## **AMENDMENTS TO THE DRAWINGS**

APPLICATION NO. 10/044,210  
AMENDMENT DATED OCTOBER 13, 2005  
REPLY TO OFFICE ACTION OF JUNE 14, 2005  
ANNOTATED SHEET SHOWING CHANGES

Fig. 1  
PRIOR ART

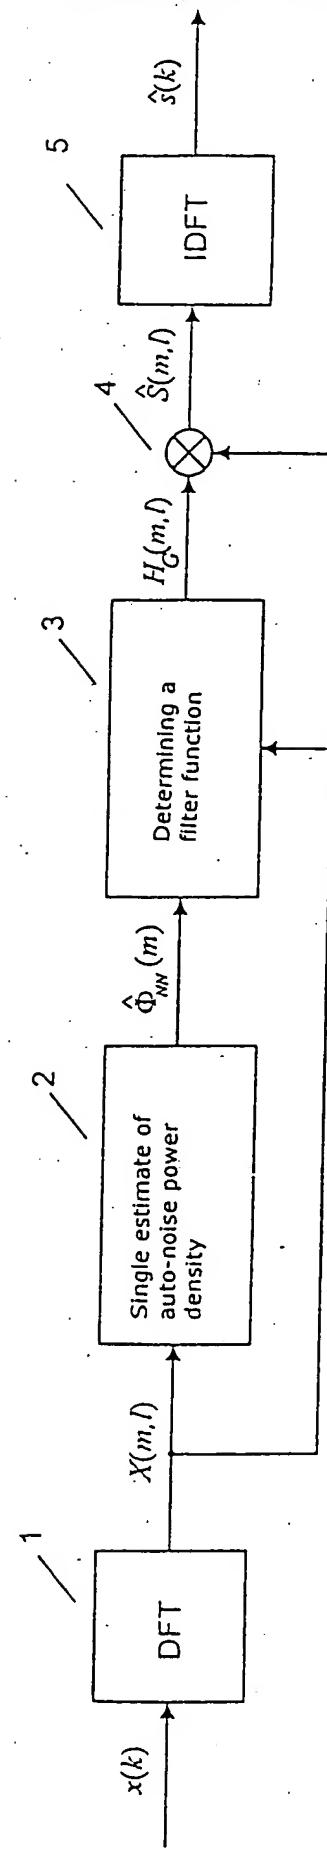
Applicants note that the drawings were objected to because Figures 1 and 2 are not designated as *PRIOR ART*. Applicants have submitted replacement sheets with corrected Figures 1 and 2 to overcome this objection.

The sheets of drawings attached in the Appendix include changes to Figs. 1 and 2. These sheets replace the original sheets filed with the application. The corrected Figs. 1 and 2 are being submitted to include the "Prior Art" legend as requested in the Office Action dated June 14, 2005.
